SUBDIVISION REVIEW SHEET
(Variance only)

CASE NO.: C8J-2011-0053.0A

SUBDIVISION NAME: Steiner Ranch MU14

ENVIRONMENTAL BOARD MOTION 092111 5b

STEINER RANCH PHASE 2 SECTION 10
PRIVATE ROADWAY
IMPERVIOUS COVER CALCULATIONS
4807 N. QUINLAN PARK RD.

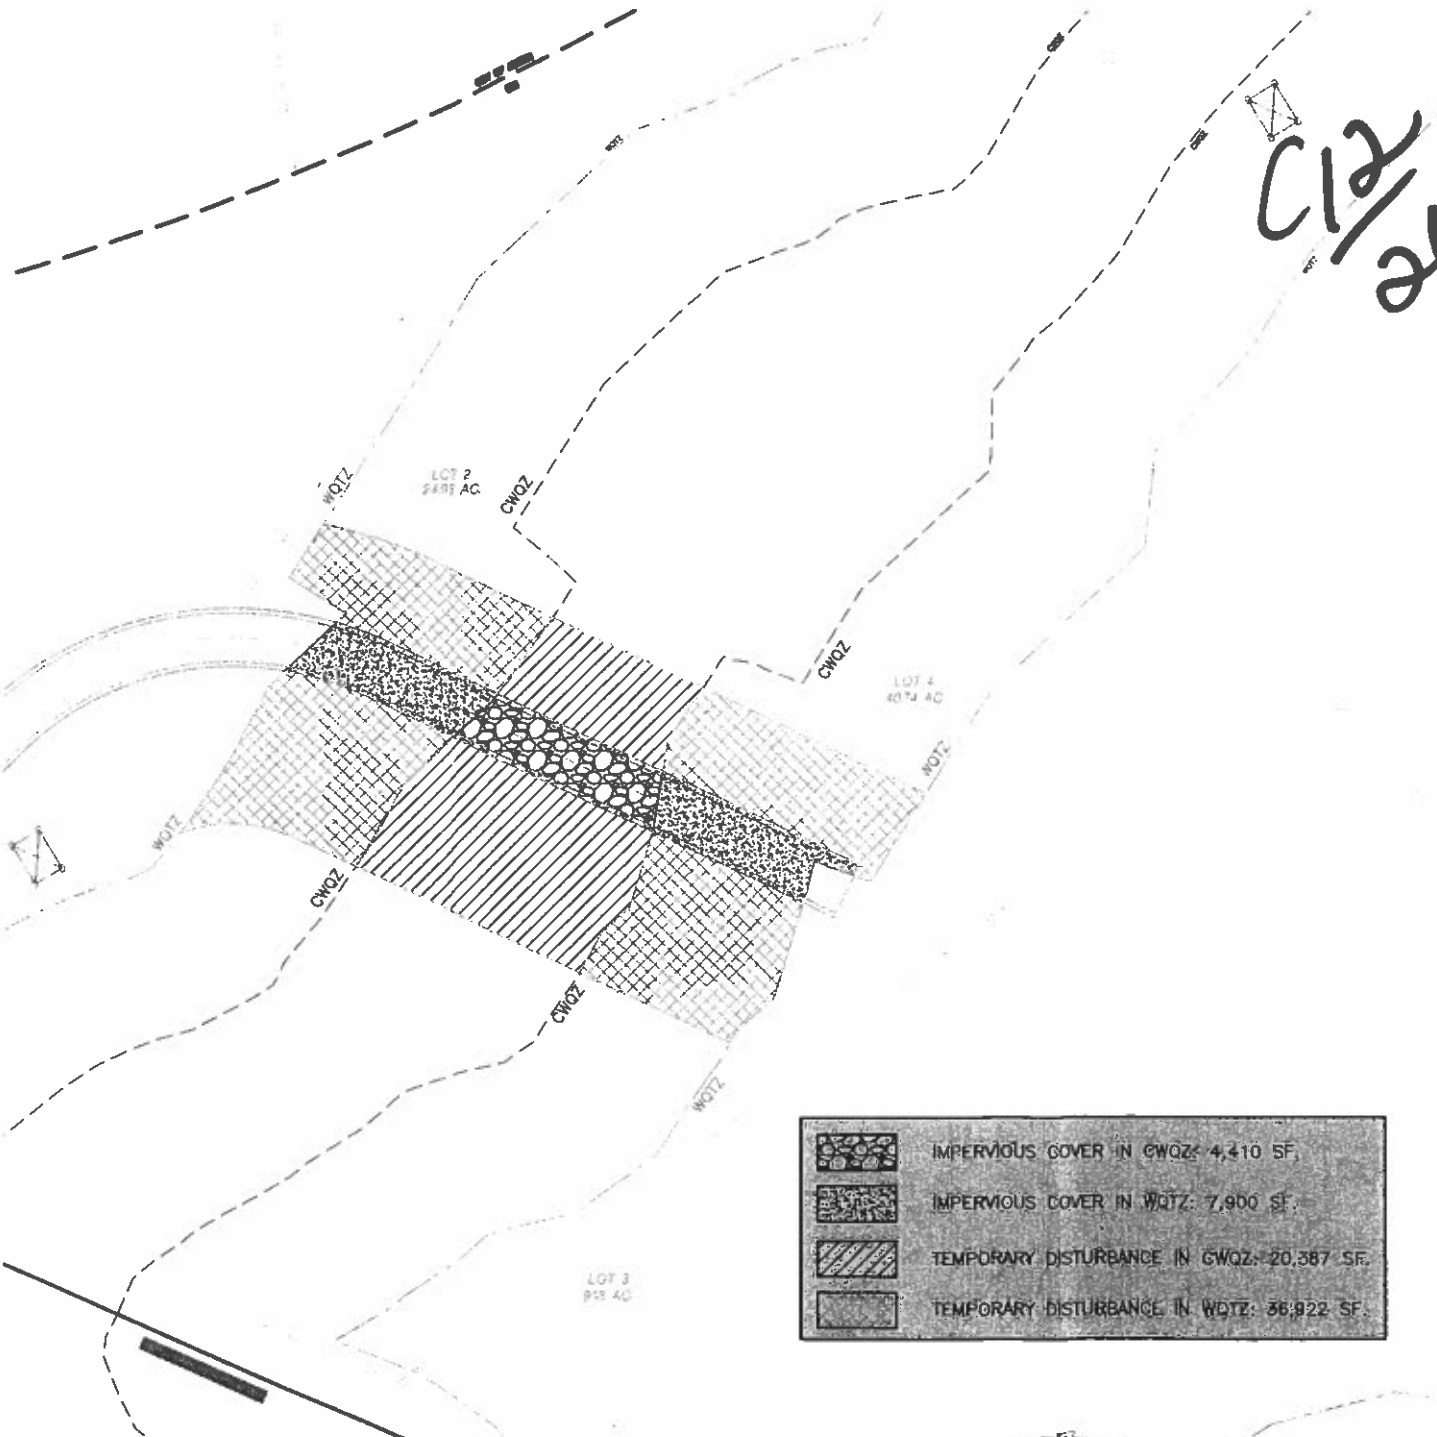
The CWQZ, WQTZ and an existing water quality pond are contained within the boundaries of the City of Austin recognized 100 year flood plan (there is no FEMA floodplain) which cuts the property in half. Without obtaining a variance to construct the proposed private street to the 18.3208 acres located on the eastern side of the draw that the property is inaccessible.

The proposed private street has been sited at the narrowest point of the WQTZ and CWQZ to minimize the amount of disturbance and impervious cover while still providing access to Lot 3 and 4.

1. The applicant will provide soil retention blanketing for all slopes over 15% in grade created or disturbed during construction to control erosion.
